October 22, 2020

Nicolas Courville, Senior Enforcement Officer, Compliance and Enforcement Unit Impact Assessment Agency of Canada Sent via email: Nicolas.Courville@Canada.ca

Re: Hardrock Project Detailed Engineering Optimization Report – Response to Letter from IAA dated September 25, 2020

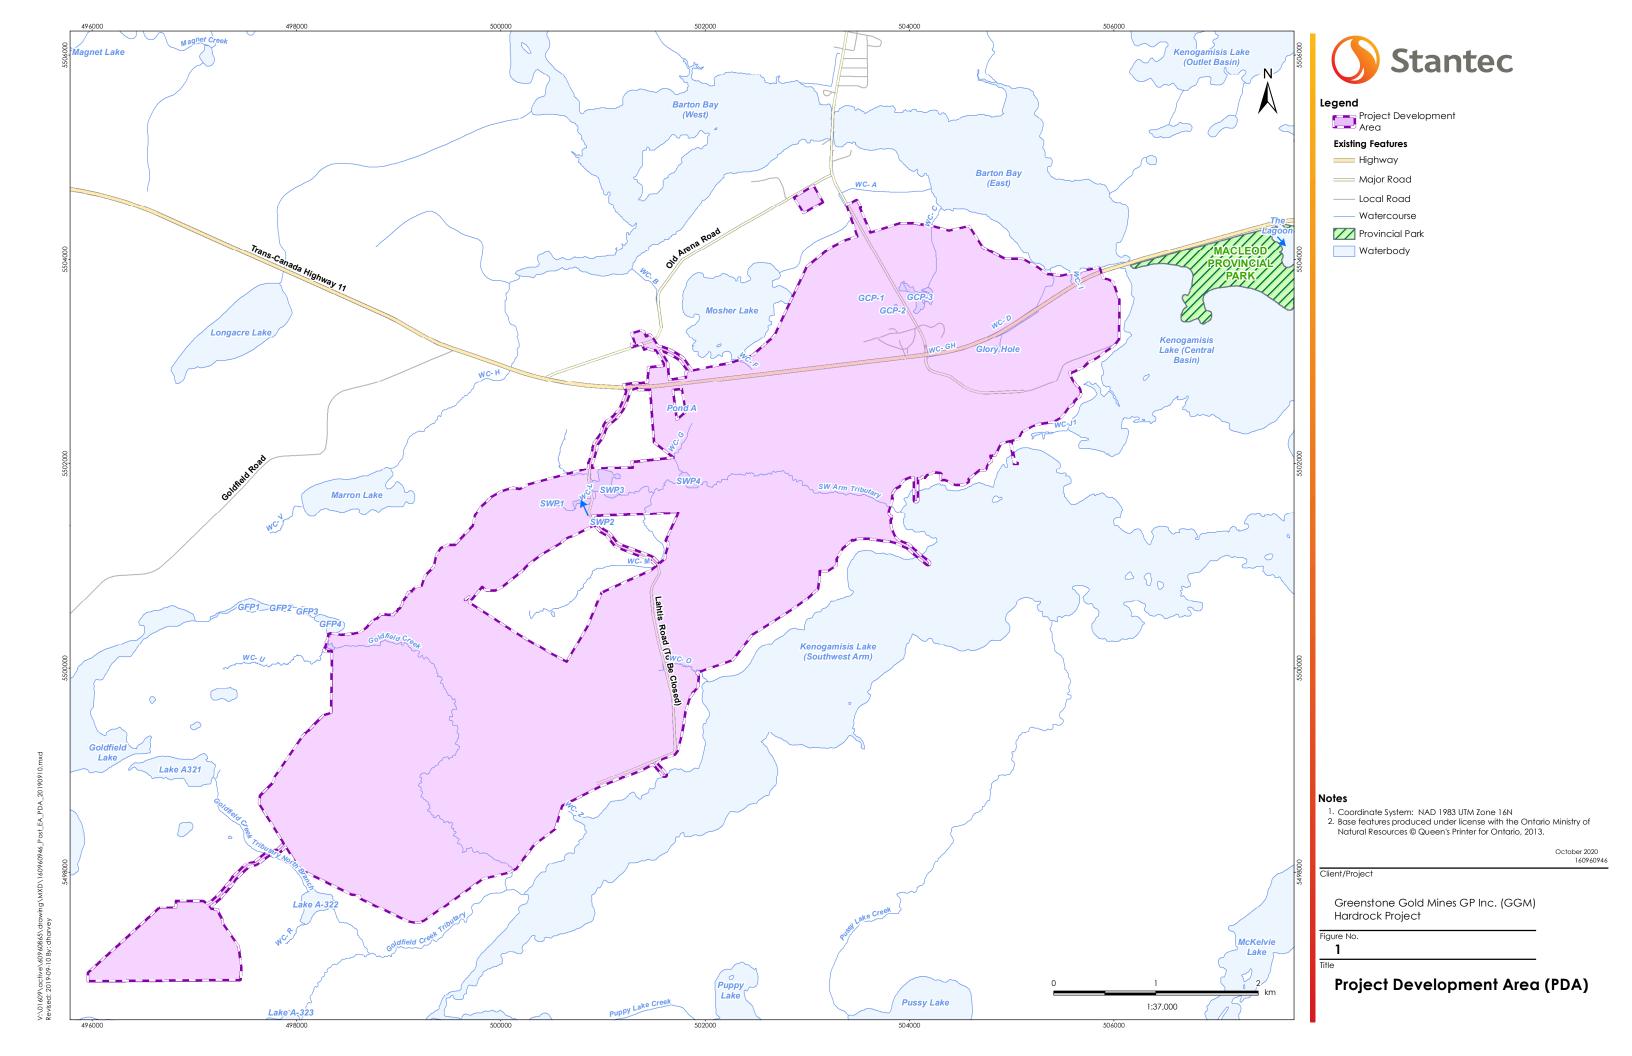
- Q3. A revised version of Figure 1 that was included in the November 2018 Environmental Assessment Report, as previously requested in the Agency's letter to the Proponent dated August 11, 2020.
- R3. Please find attached a revised version of Figure 1.

As requested, please find attached a figure to show the minor adjustments to Project development area (PDA). To accompany this figure and supporting GGM's interpretation of the work, GGM would like to highlight the following key points regarding the engineering optimizations that have been made and their relation to the PDA as documented in the EIS.

- Compared to the EIS the overall PDA has been reduced in size by two hectares (ha); from 2193.4 ha to 2191.4 ha.
- Aggregate source T2 and access road:

- o The refined aggregate pit boundary is entirely within GGM mineral claims, and is now 43 ha smaller in size compared the area identified in the EIS. GGM has left the larger footprint as part of the PDA for consistency with the EIS/EA and to provide operational flexibility. The boundary only extends only 0.86 ha immediately adjacent to the PDA, which equates to a very minimal 0.00039% increase in the PDA.

- The improved access road to aggregate source T2 has multiple benefits including avoidance of topographic constraints (safer gradient), avoidance of an existing wetland, and a reduced footprint (0.7 km shorter than the original access road).

- Aggregate source S1:
 - The boundary extends only 1.7 ha immediately adjacent to the PDA which equates to a very minimal 0.00076% increase in the PDA; In addition, no aggregate extraction will occur in the area outside of the PDA. Rather the area identified is only intended to keep clean non-contact runoff away from the extraction zone.

- Temporary effluent treatment plant (ETP) discharge pipeline:
 - Benefits of the detailed engineering design include avoidance of shoreline habitat and increased effectiveness of mixing and dispersion of effluent, particularly during the winter months when there is ice buildup. This item has already been permitted by the province.

- Sand washer seasonal water taking:
 - o The intake line only extends approximately 300 m in a direct line from the PDA to the lake.
 - o The volume of water taking is consistent with the EIS/EA.

- Operational effluent treatment plant discharge pipeline (including the access road):
 - The effluent line was included in the EIS and has been improved to reduce the length within the 120-m shoreline zone from approximately 430 m to 135 m.

- Fresh water intake pipeline (including the access road):
 - The water intake line was included in the EIS and has been improved to avoid wetlands surrounding the Southwest Arm Tributary. The length remains comparable to the EIS.

- Power line and transformer station access road:
 - The required access road to the Longlac Transformer Station was included in the EIS and only required minor adjustment to accommodate Ministry of Transportation spacing requirements on a controlled access highway as identified during permitting.
